**Re: A request by Jeff and Cynthia Reed for approval of the Preliminary Plat of Oak Valley Addition a proposed eight (8) lot subdivision, located east of Coon Hunters Road and north of 113<sup>th</sup> Street in part of the SW¼ of Section 15, Buffalo Township.**

**Re: Revised Oak Valley Addition Preliminary Plat**

STAFF REPORT

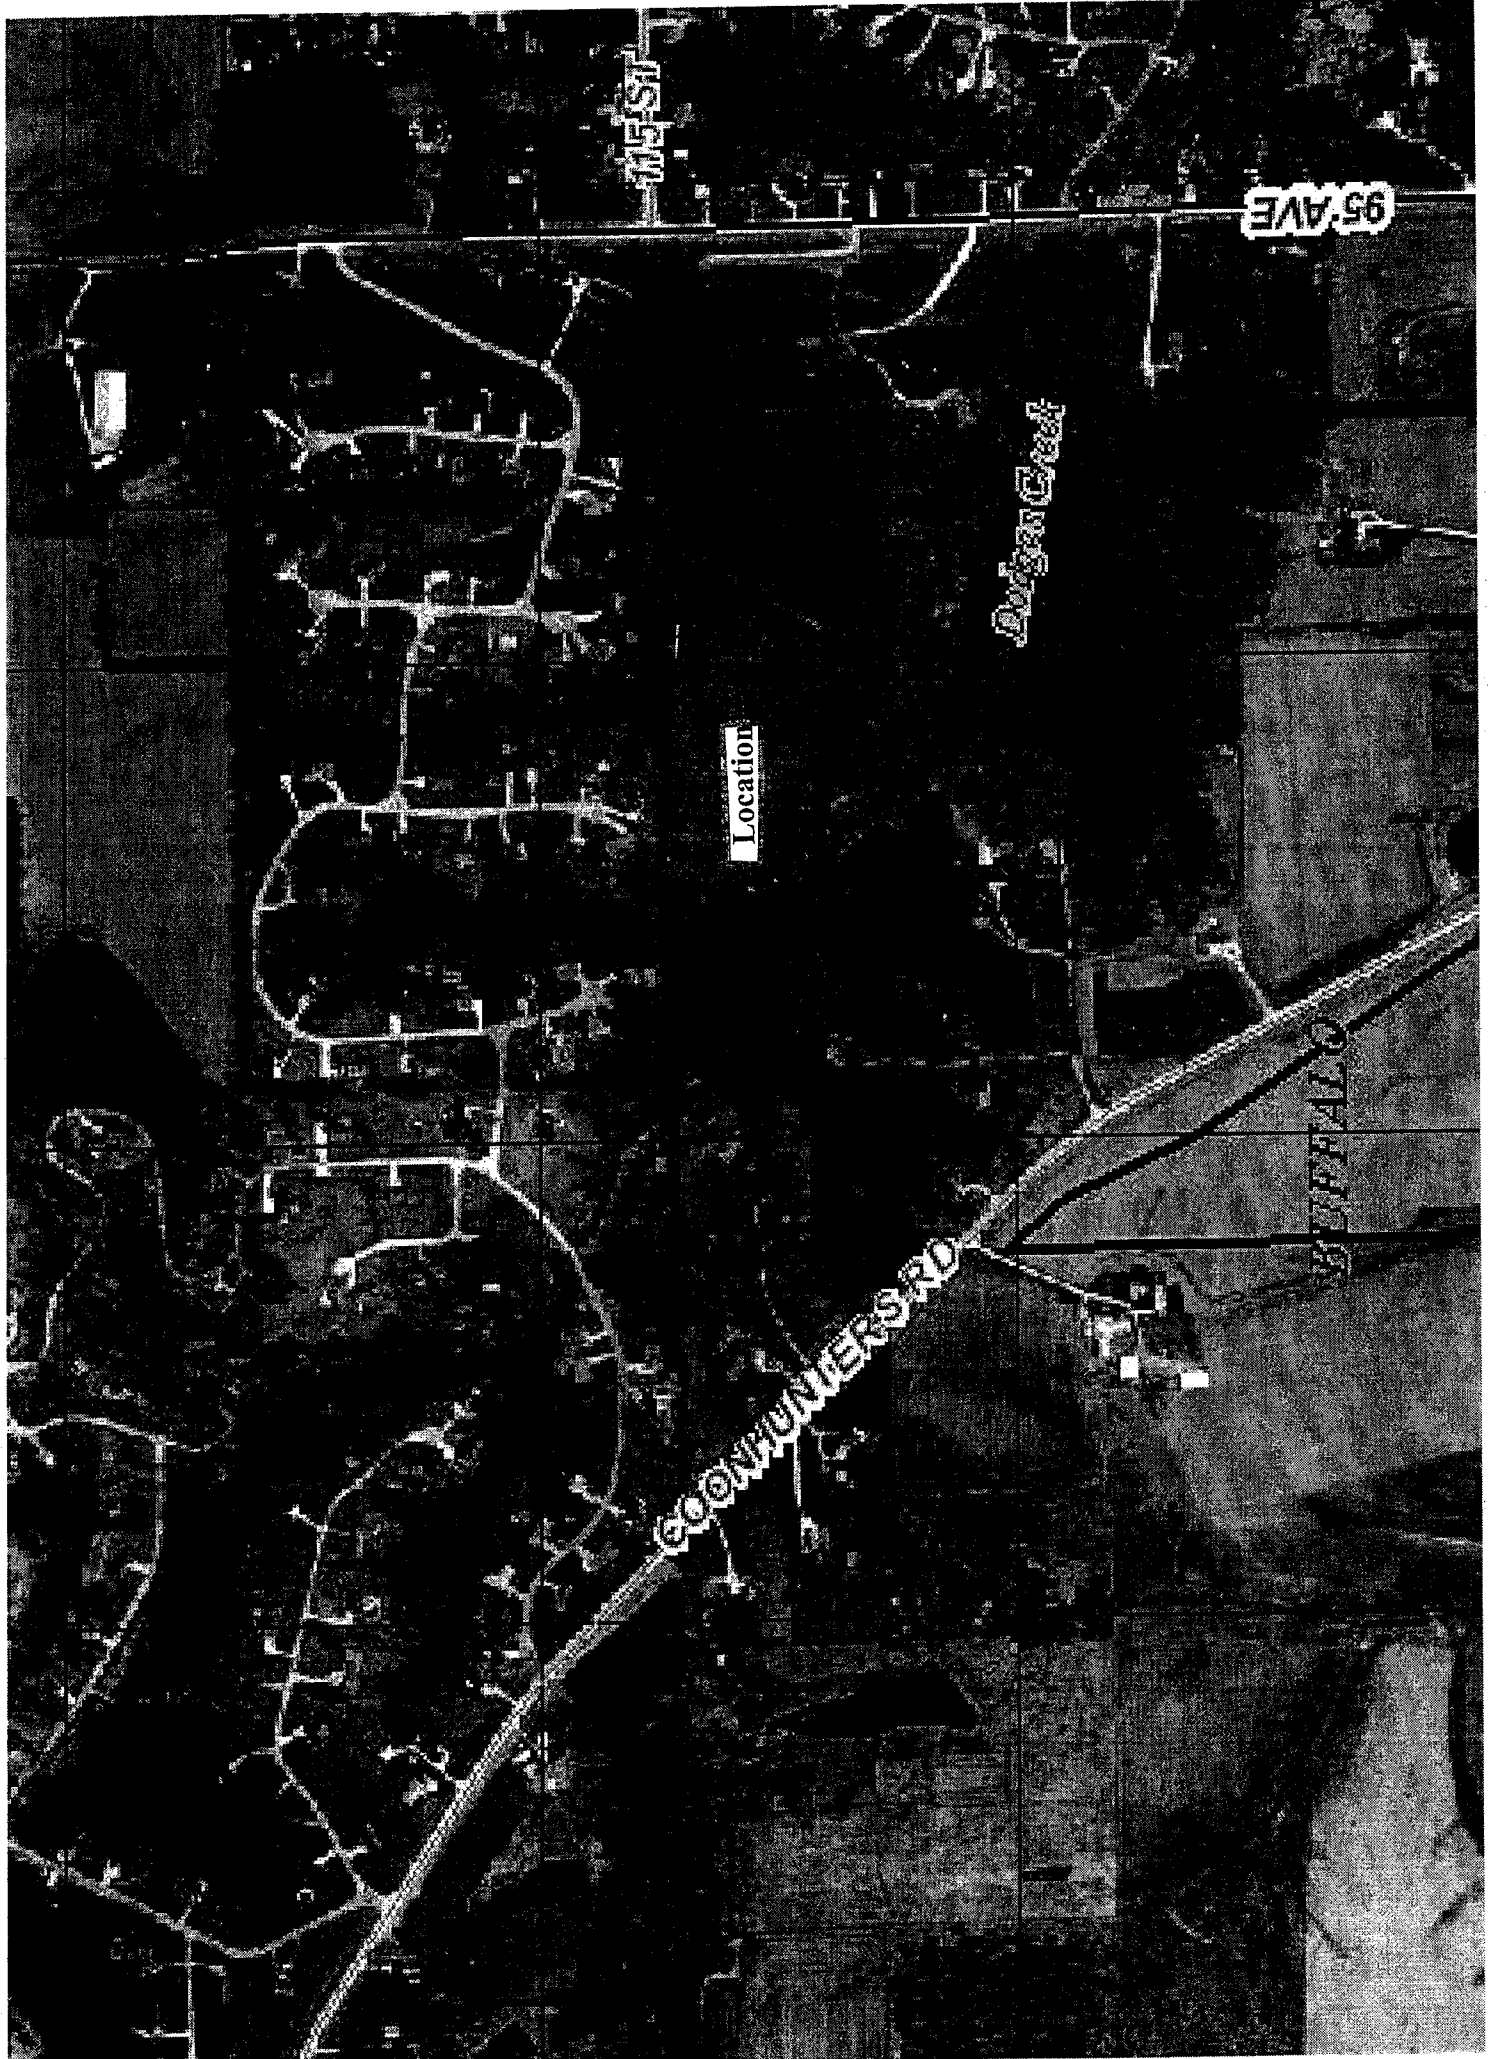
The Planning Commission unanimously recommended approval of the Preliminary Plat with six conditions in accordance with staff's recommendation. The Planning Commission had tabled its review of this Preliminary Plat, with the consent of the applicant, at its December 4<sup>th</sup> and January 8<sup>th</sup> meetings. The Planning Commission's discussion at the previous meetings dealt with its concerns on the length of the proposed cul de sac and the number of lots to be served on that cul de sac. The Planning Commission also had concerns with the inadequate existing access to the property off of Coon Hunters Road with a twenty five foot flag pole being a shared driveway to the applicant's two houses, three neighboring residences and three existing undeveloped lots the applicants owned. Some of the previous versions of the Preliminary Plat increased the numbers of lots to use this shared driveway for access. The Planning Commission indicated that it recommended the applicant upgrade this access by providing an adequate turnaround and increasing the width of the paved access. Without acquiring additional property from the adjacent land owners the width of the easement cannot be increased, therefore any increase in the paved width of that shared driveway would need to be within the twenty five foot wide flagpole. The Planning Commission also indicated that it would not recommend approval of any plat that resulted in more lots accessing this relatively narrow easement.

The revised Preliminary Plat the Planning Commission reviewed showed a widened paved roadway within the 113<sup>th</sup> Street flagpole, a paved turnaround bulb at the end of that drive and no increase in the number of lots served by that access. This revised plat also shows seven lots on the extension of the northern cul de sac, resulting in no more than thirty lots served by a single entrance.

**RECOMMENDATION:** The Planning Commission recommends that the Revised Preliminary Plat of Oak Valley Addition dated 1/30/08 be approved with the following conditions:

1. That a variance to the Subdivision Regulations be approved to allow the proposed cul de sac to exceed the maximum length based on the minimal nature of the request, that there is no feasible alternative, and that the maximum numbers of thirty (30) lots served by a single access is not being exceeded;

2. All grading and construction comply with the erosion and sediment control plan as approved by the County Engineer and the Natural Resources Conservation Service;

3. The proposed wastewater treatment facilities meet Health Department and Iowa Department of Natural Resources requirements;
4. The existing shared access drive and proposed cul de sac bulb be constructed and hard surfaced to a minimum width of 18 feet and 40 foot radius;

5. The County Engineer review and approve all street construction plans prior to construction; and
6. The subdivision infrastructure improvements be completed or a surety bond posted prior to Final Plat approval.
